CPC - ALTON RD
1801 ALTON RD.
MIAMI BEACH, FL 33139

Re:	PC #:	B1103915
	Commercial Plan Review Dated:	8.17.11
	Project Name:	Chase – CPC Alton
	Address:	1801 Alton Road
	Occupancy:	B

(Revision 3, PLAN REVIEW COMMENTS, dated 04-22-2013)

In response to the current City of Miami Beach building review comments, the following items are enclosed for your review and approval of the above referenced project:

FLOOR PLAN - LIGHTING

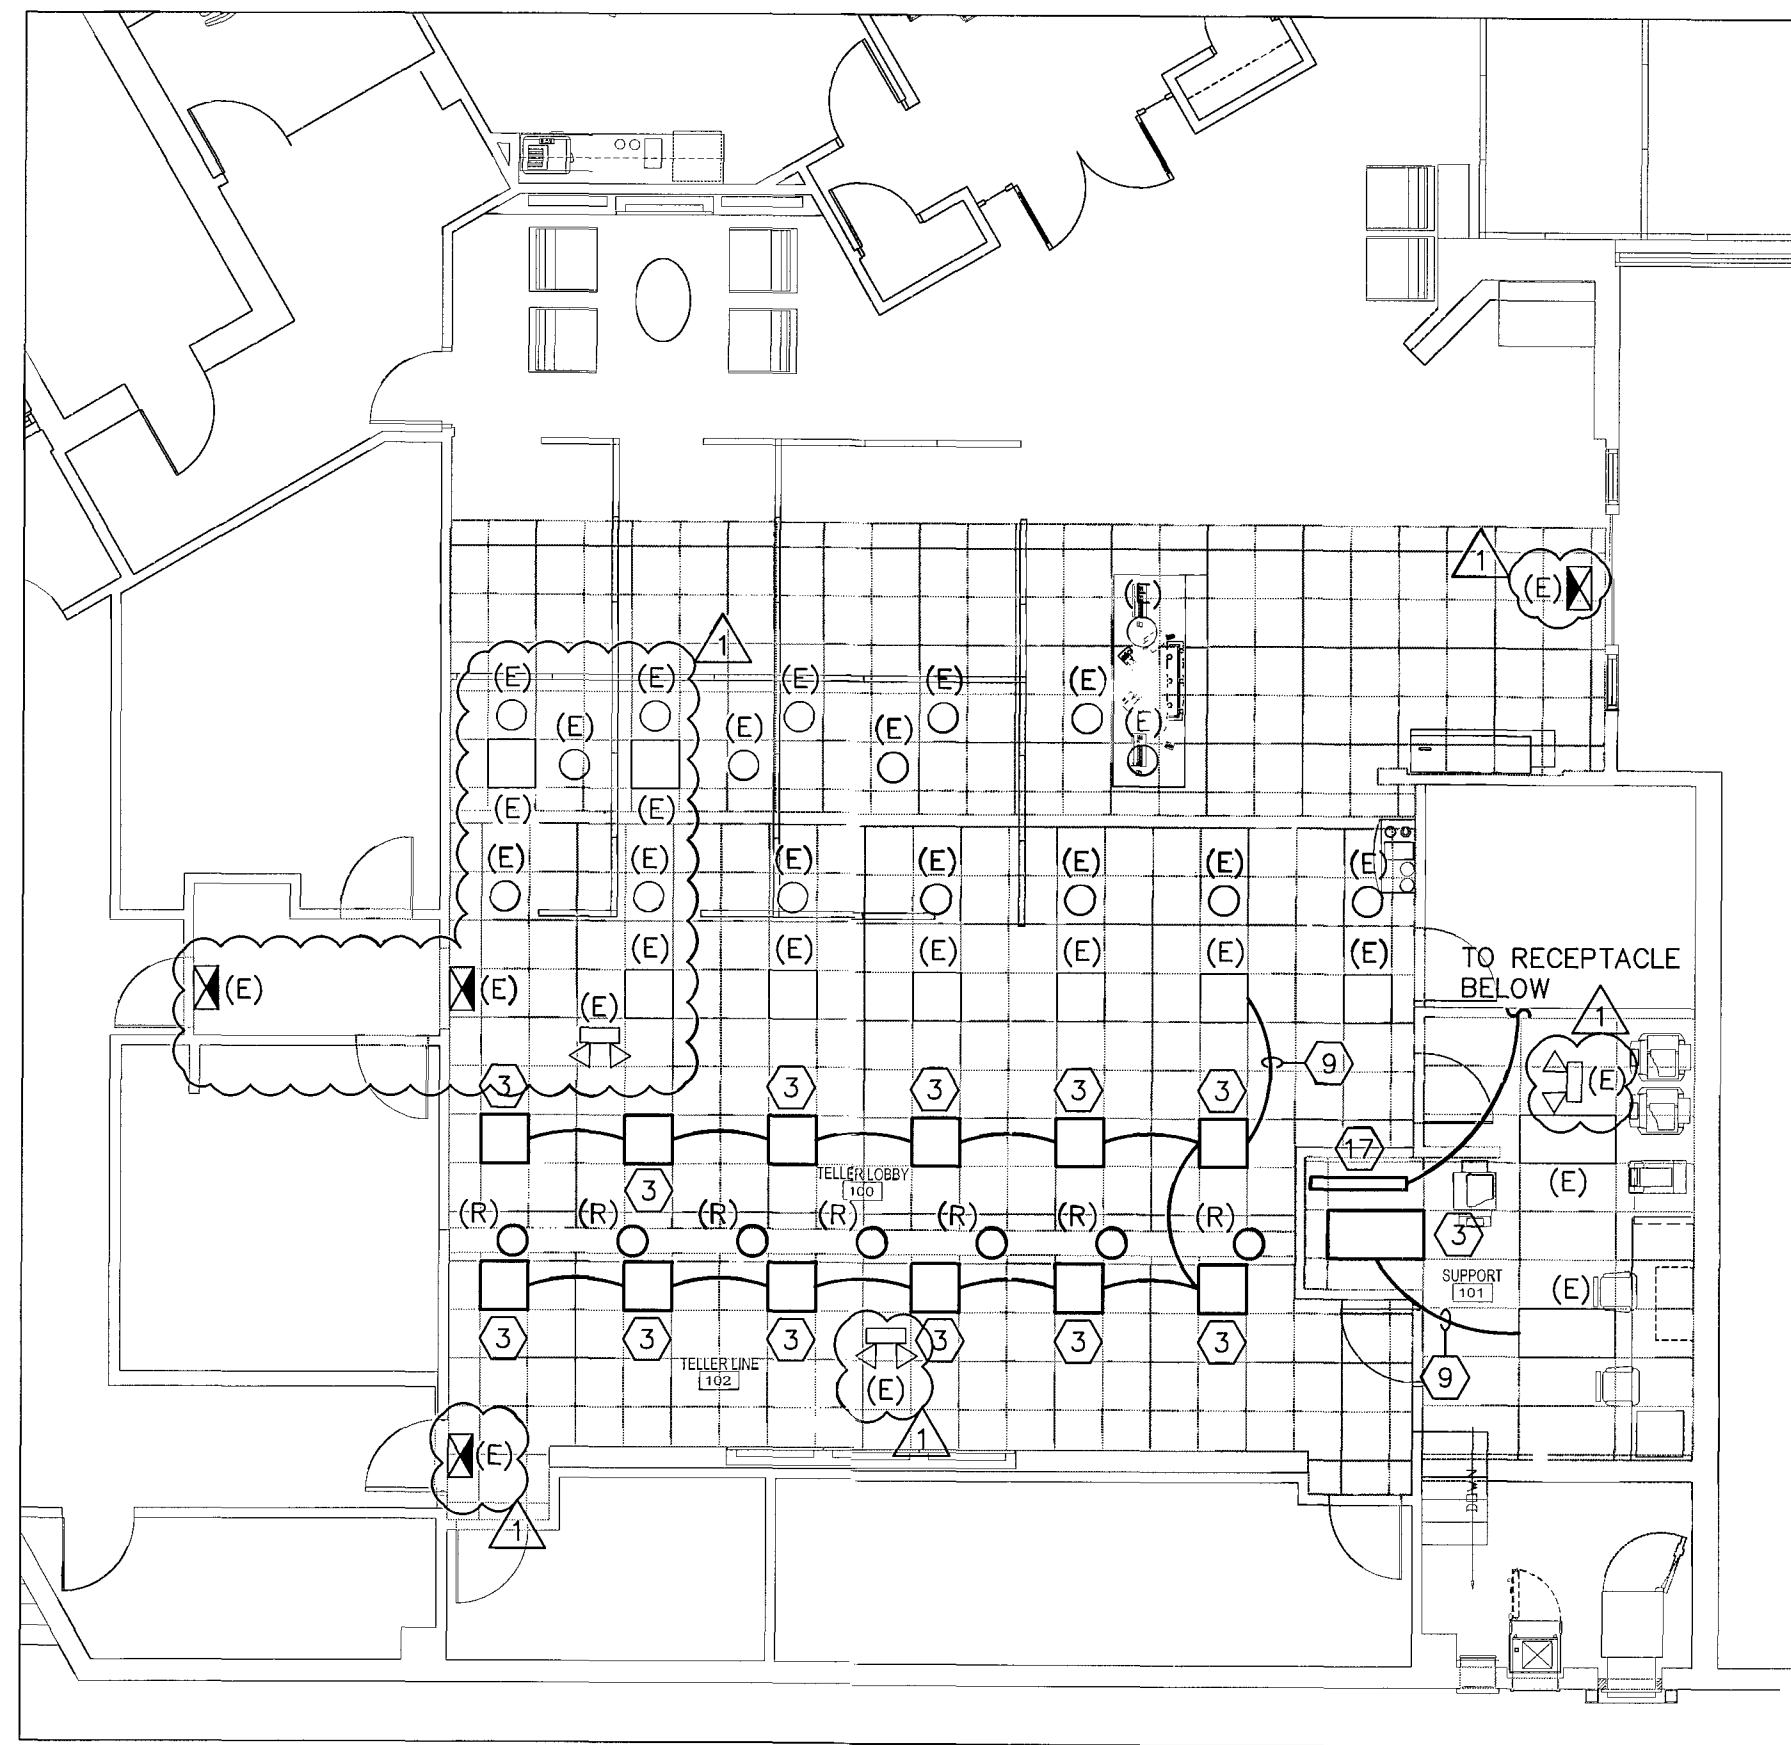
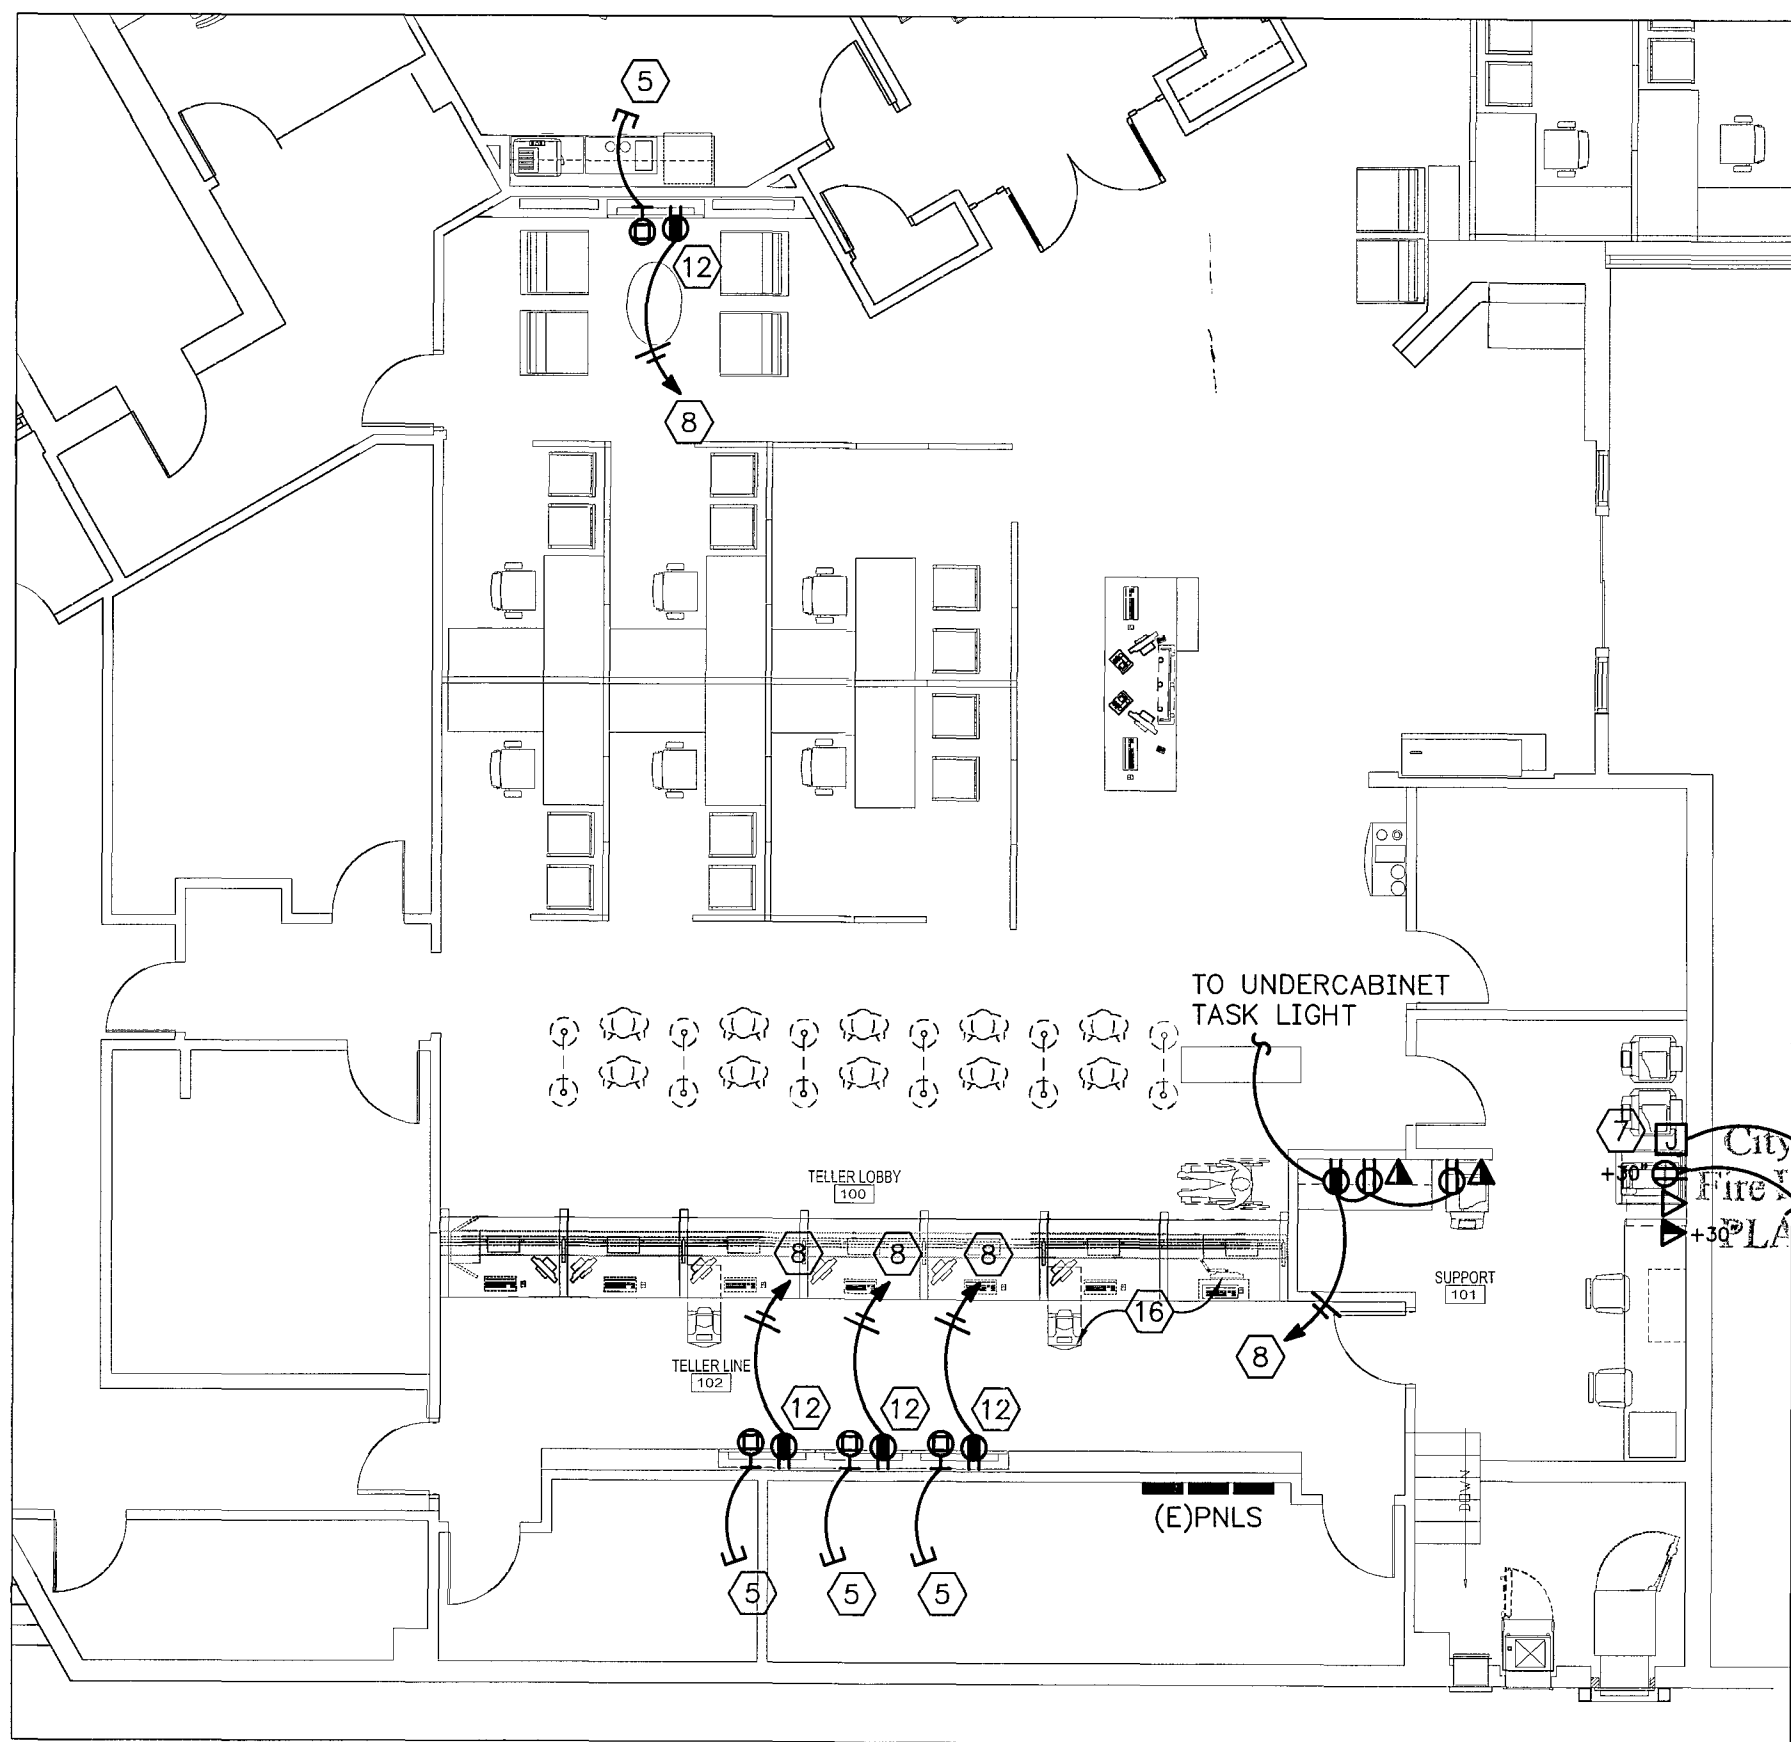
8. Label all areas sheet e100: 1. show location of emergency lights and exit signs, clarify if these items have battery backup rated for 90 min note once the architect/engineer answers the comments additional comments may follow.

RESPONSE: Please refer to the attached revised sheets A1.1 (reflected ceiling plan) and E100 for locations of emergency lights within the area of work. Areas have been labeled on sheet E100.
